**AGENDA
CITY OF CEDAR FALLS, IOWA
PLANNING AND ZONING COMMISSION MEETING
WEDNESDAY, AUGUST 28, 2019
5:30 PM AT CITY HALL**

TO: Planning and Zoning Commission
FROM: David Sturch, Planner III
DATE: August 21, 2019
SUBJECT: Land Use Map Amendment

TO: Planning and Zoning Commission
FROM: Iris Lehmann, AICP, Planner II
DATE: August 22, 2019
SUBJECT: Façade review of property in the Central Business District Overlay

TO: Planning & Zoning Commission
FROM: Iris Lehmann, ACIP, Planner II
Matt Tolan, Civil Engineer II
DATE: August 22, 2019
SUBJECT: Panther West Preliminary Plat

PROJECT 5722
SHEET NO. 4 OF 5

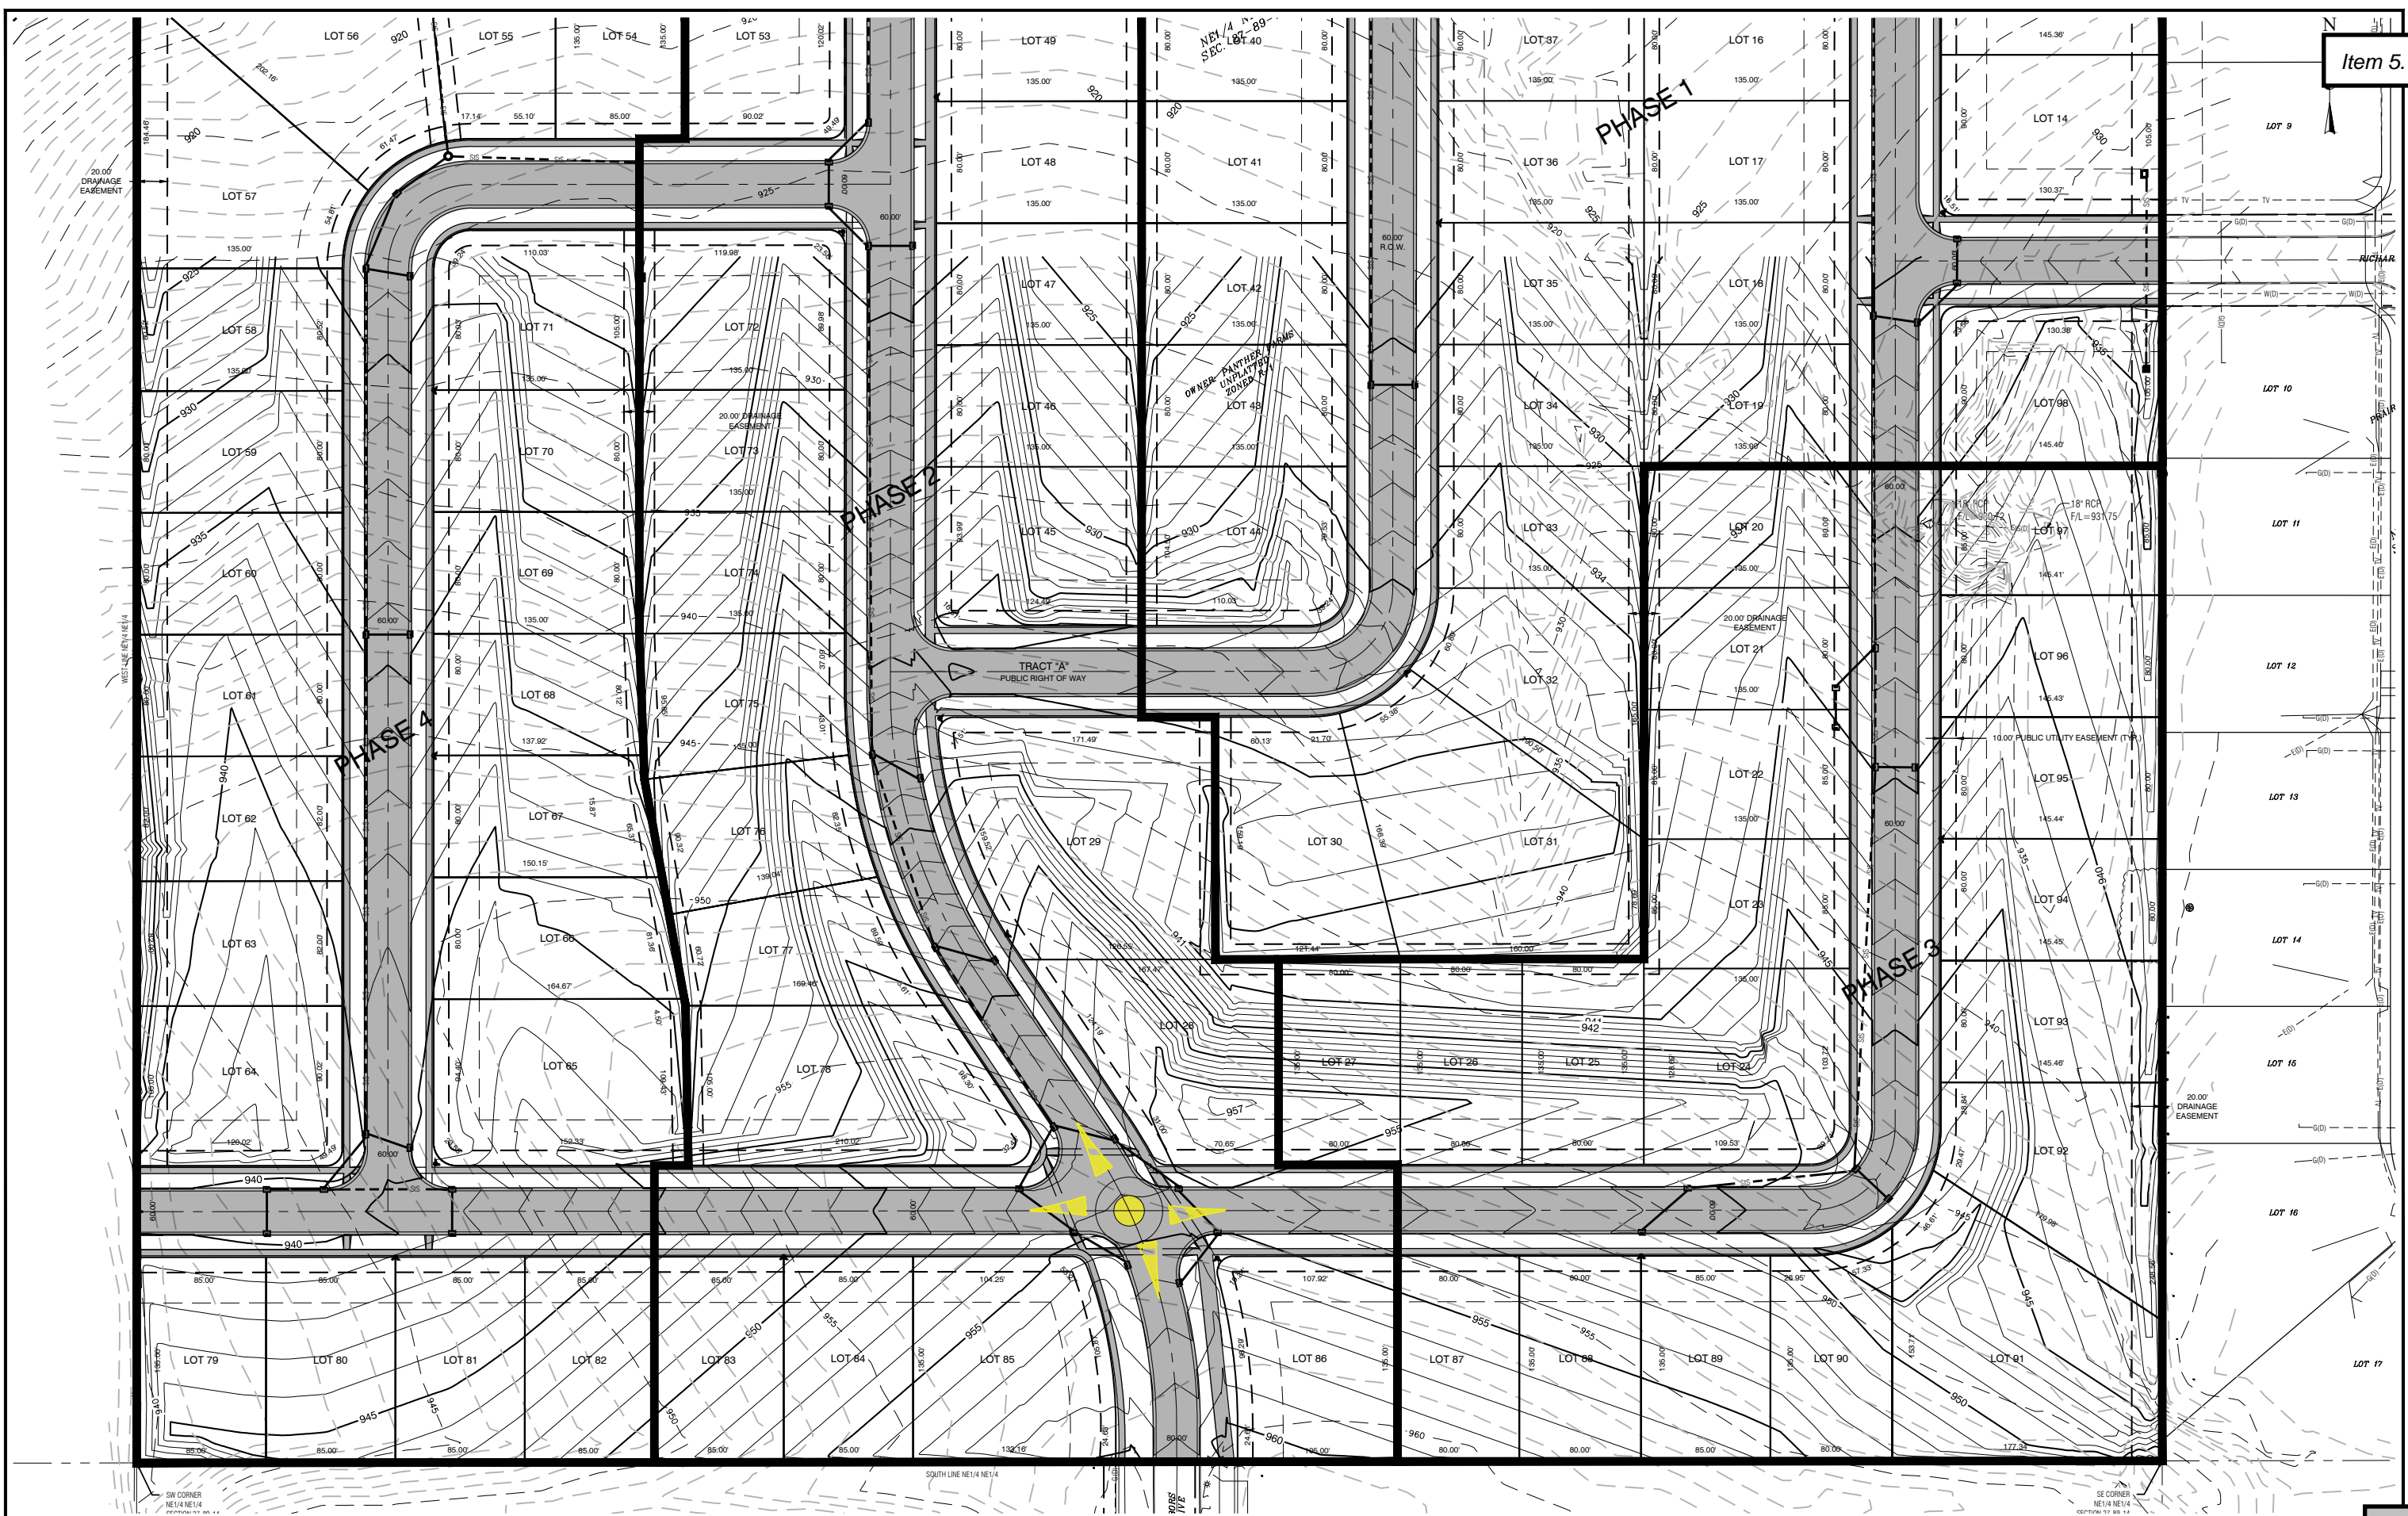
5. Add a drainage easement on the west side of lot 79.
6. Add a public access easement to Tract D and address responsibility for maintenance to the deed of dedication.

7. Add language at the end of item #18 of the Deed of Dedication to read as follows: "The location of the clustered mailboxes shall be approved by the City of Cedar Falls".

8. Change note #2 in the Deed of Dedication to "Contractor shall confirm the location of the cluster mailbox with the City of Cedar Falls prior to installation".

9. Show proposed locations of the cluster mailboxes on the preliminary plat.
10. Show the property owners within 200 feet of the plat.
11. Provide details on where the driveways will be placed on lots 86, 85, 78, 51, 48, 28, and 18. Staff has concerns with how these driveways may relate to the sidewalk crossings on these lots or the adjacent traffic circle.

The proposed Panther West Preliminary Plat is consistent with the development intent of this area and serves as an intermediate step in the development of this site. Staff recommends gathering any comments from the Planning and Zoning Commission and the public and then continuing the discussion of the proposed subdivision plat at the next Planning and Zoning Commission meeting on September 11, 2019. Approval will be subject to the resolution of the technical comments listed above.
